Enclosure 1

COLA will be revised as shown in this enclosure. These mark-ups are based on COLA Rev. 6 and replace those provided in RAI 03.07.01-29, Supplement 1 in their entirety.

3H.10 STP 3 & 4 Resolution of Issues with Subtraction Method of Analysis Identified by DNFSB

Figure 3H.6-226: SSI, SSSI, ASCE 4-98 and Design Lateral Seismic Soil Pressures on Diesel Generator Fuel Oil Storage Vault No. 1B North Wall

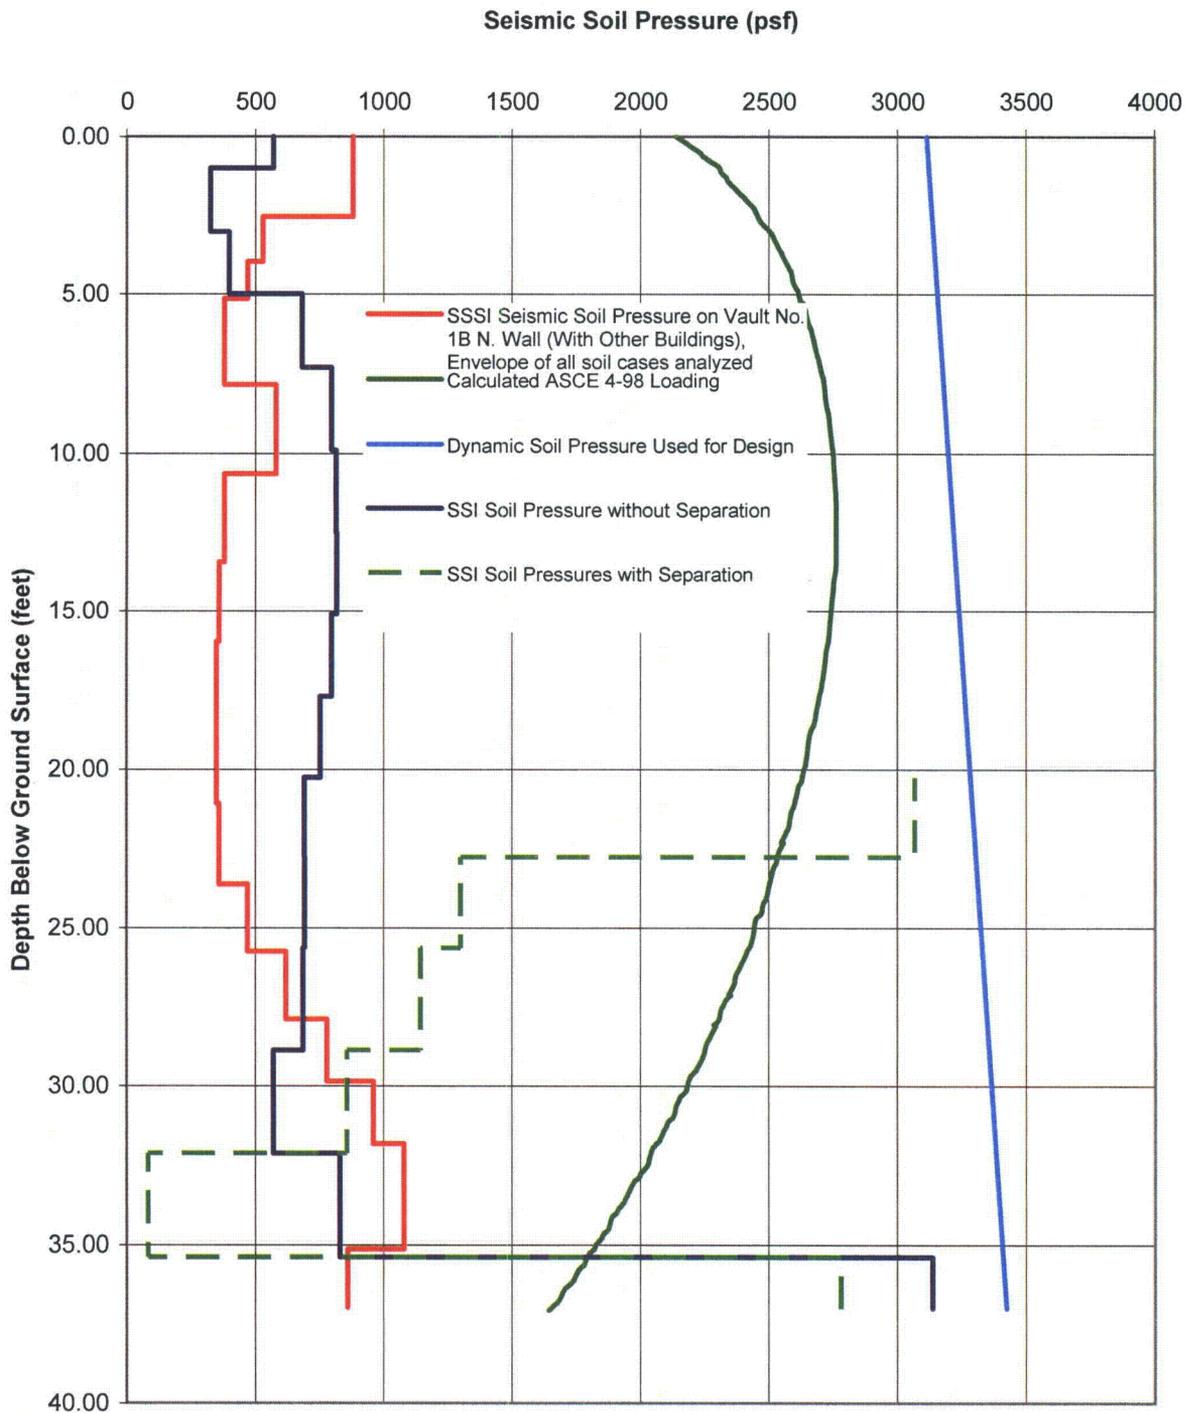
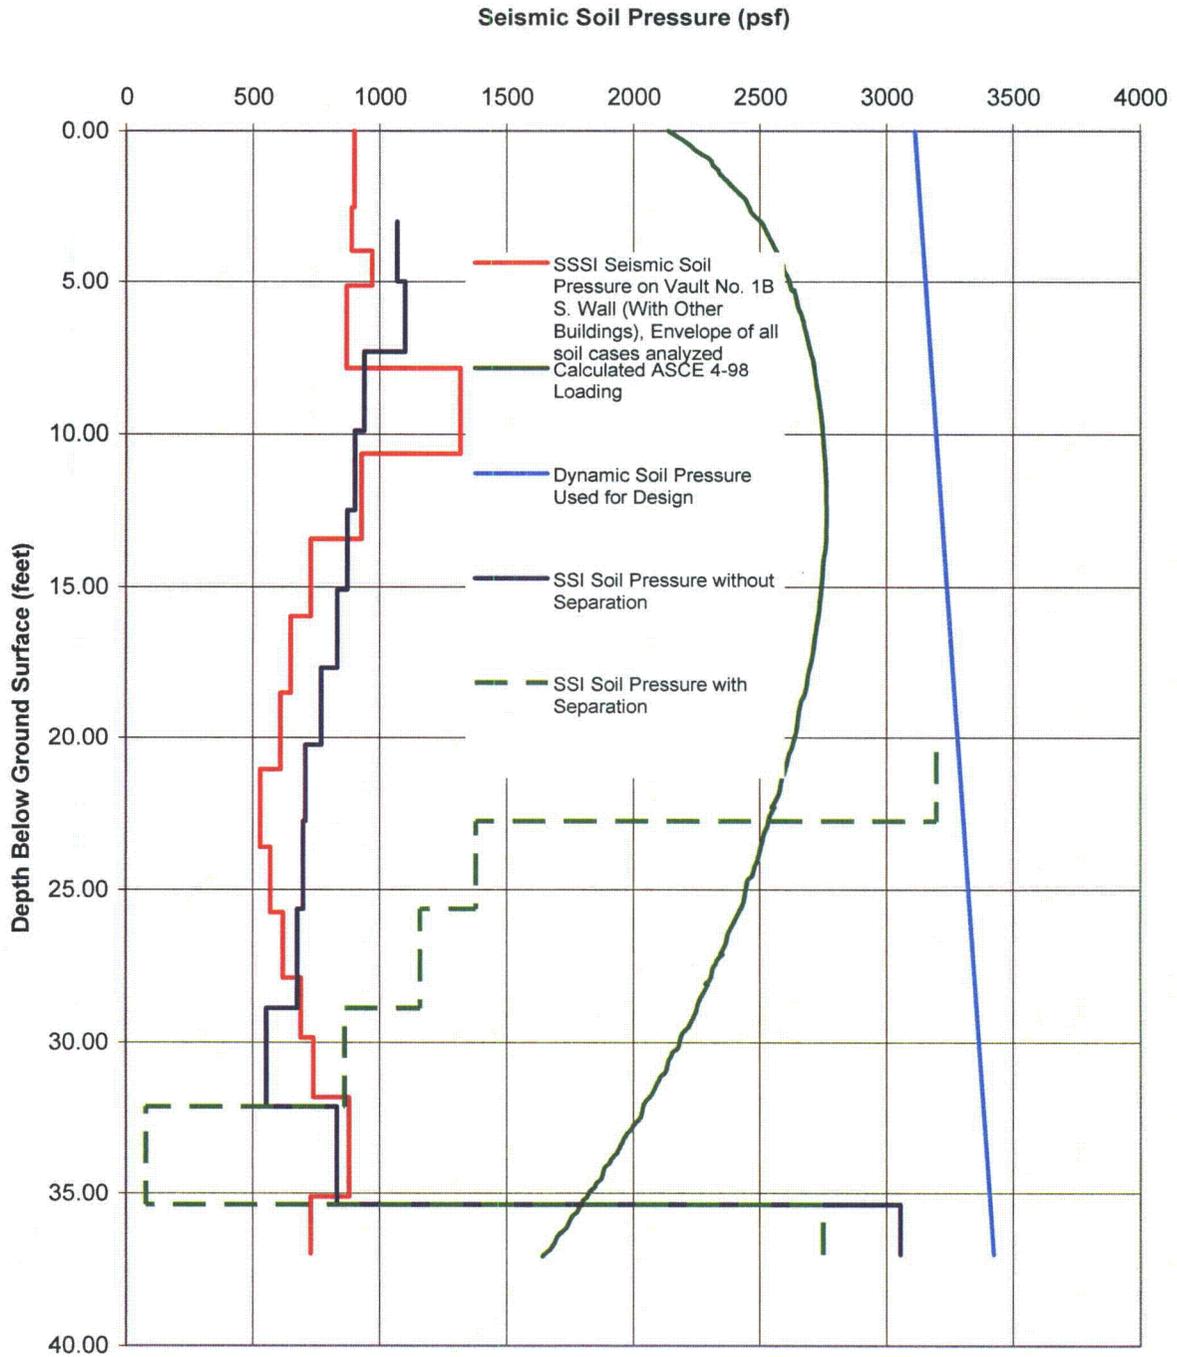
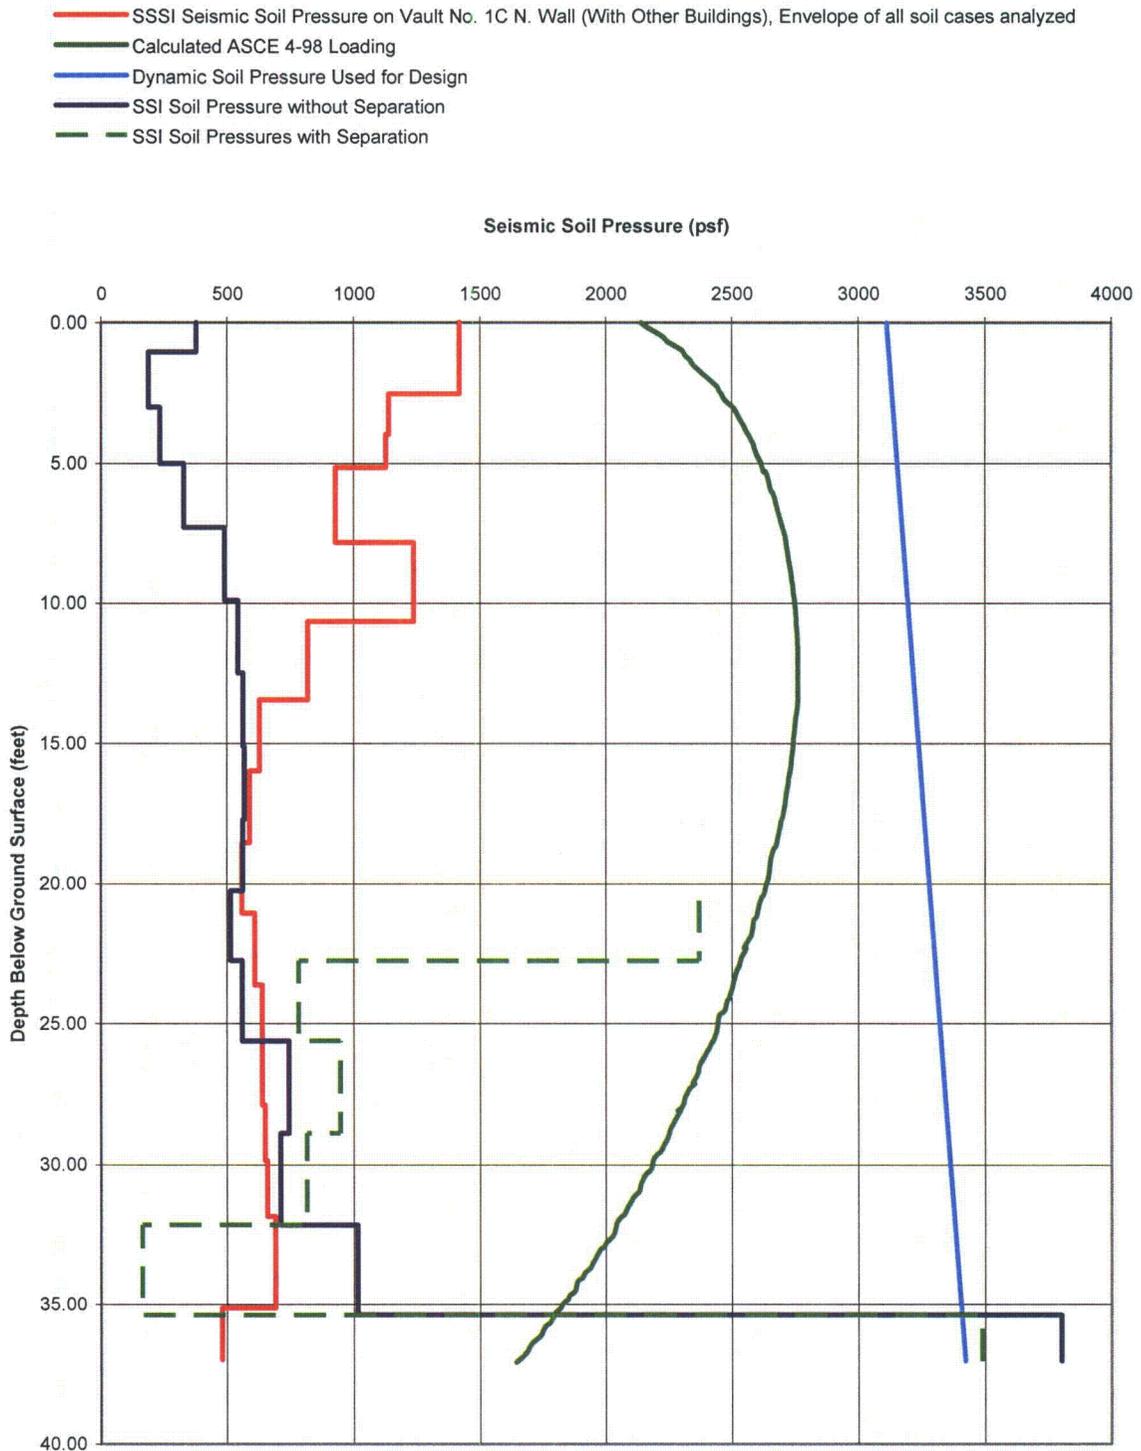
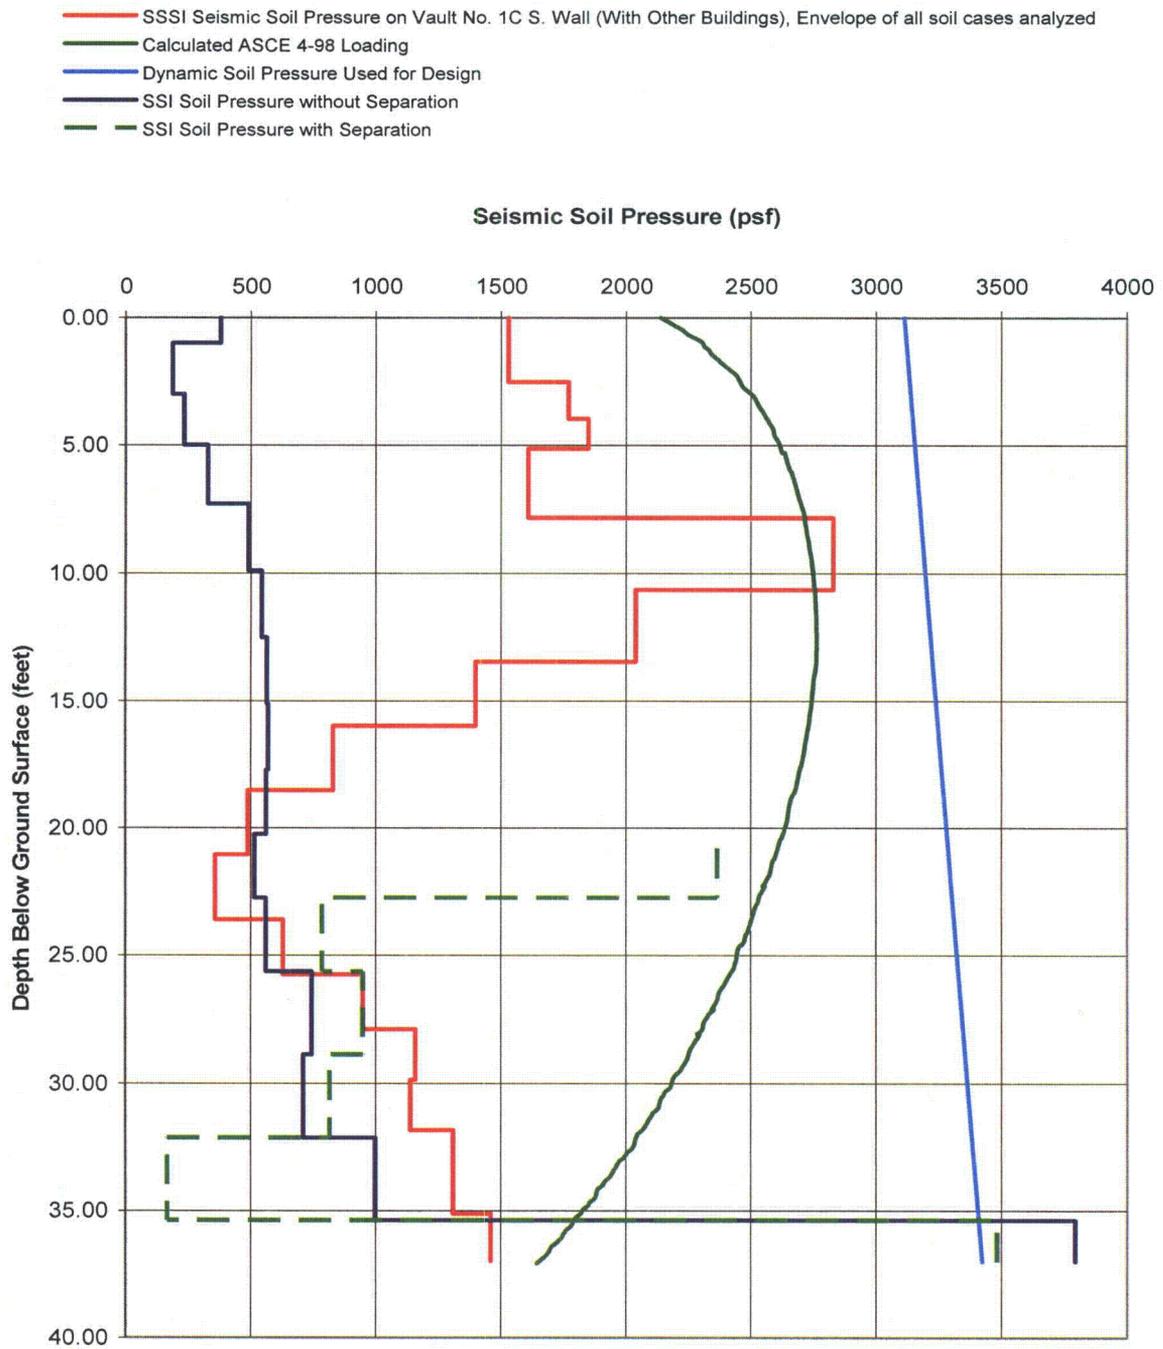
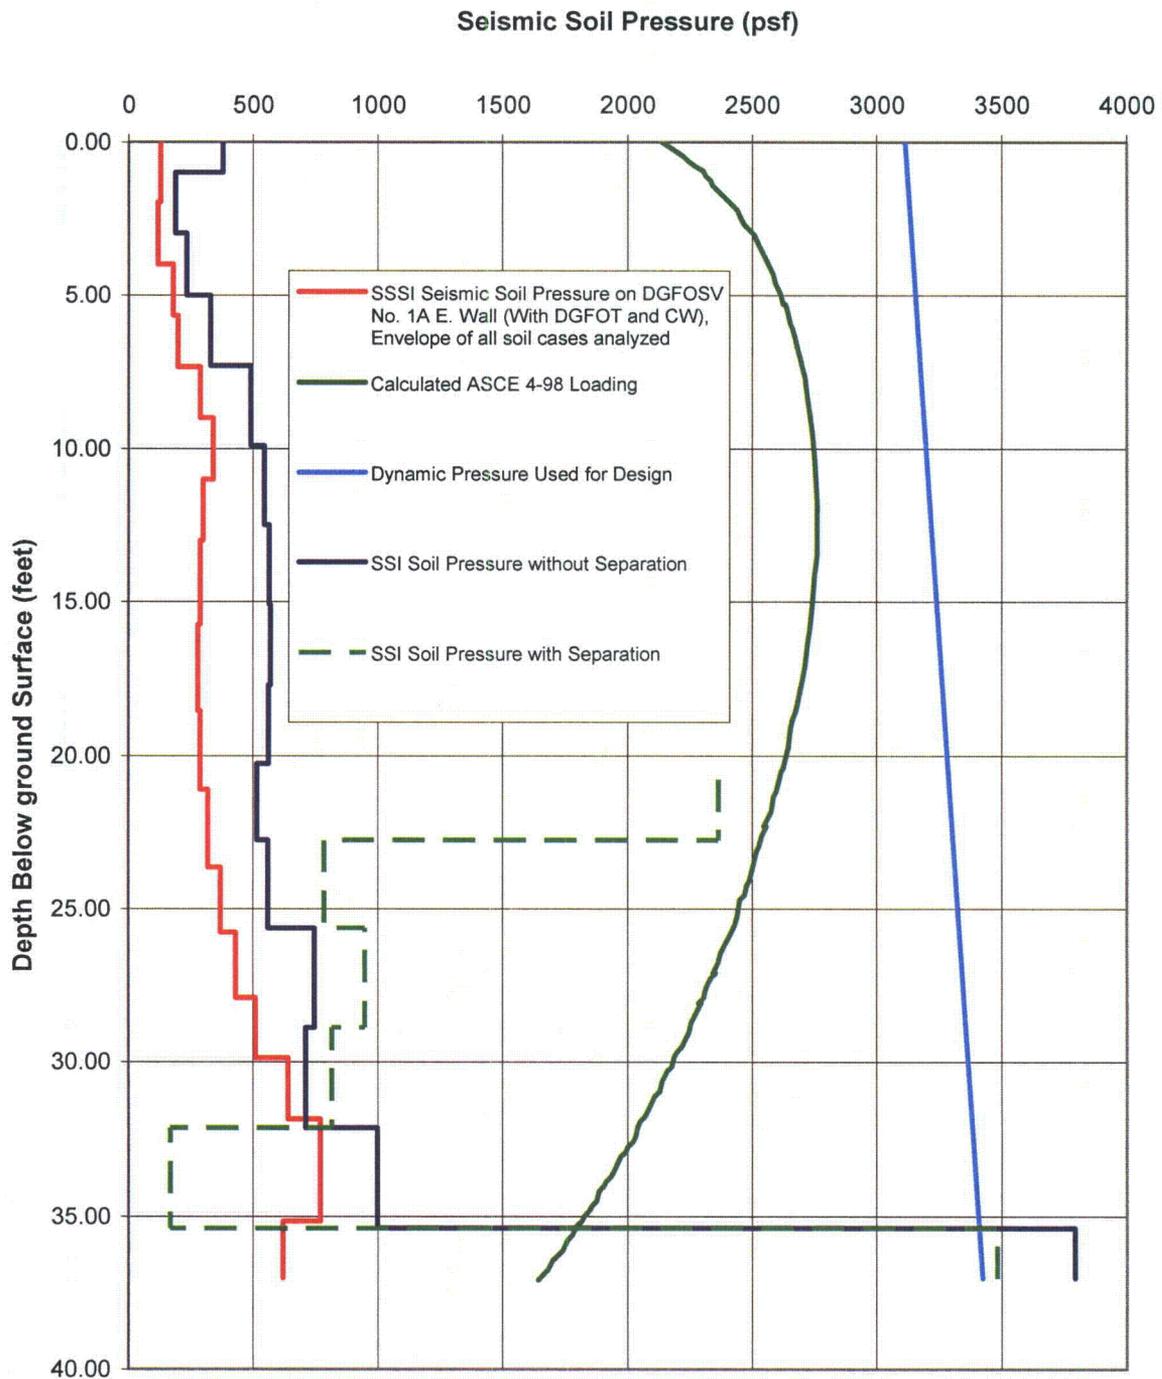
The SSSI analysis of the 2D model of DGFOV with other structures, which affects the DGFOV in the East-West direction is performed using SASSI2000 computer program, using subtraction method. For resolution of issues with the subtraction method of analysis identified by the Defense Nuclear Facilities Safety Board (DNFSB) see Section 3H.10. The following provides the details of this SSSI analysis.

The strain dependent soil properties used in the model are in accordance with the properties provided in Table 3H.6-1 for the in-situ soil, and Table 3H.6-2 for the backfill soil, with the exception that for soil layers below the ground water table, the Poisson's ratio is capped at 0.495 for determining the compression wave velocity. The thickness of soil layers are adjusted to provide a vertical direction passing frequency of at least 33 Hz (based on one fifth of shear wave length criterion).

Based on the site groundwater conditions originally described in FSAR Subsection 2.4S.12, the groundwater elevation of approximately eight feet below grade (26 feet MSL) was used in the analysis to determine the soil properties. Subsection 2.4S.12 and Table 2.0-2 now state the groundwater elevation as 28 feet MSL. Therefore, a sensitivity analysis of this change in groundwater elevation was performed using the Diesel Generator Fuel Oil Storage Vault SSI model, which showed no significant effect on the analysis results.

The incremental seismic soil pressures used in design, which envelope the incremental seismic soil pressures from the SSSI analyses and those computed per Subsection 3.5.3.2 of ASCE 4-98, are shown in Figures 3H.6-226 through 3H.6-231.
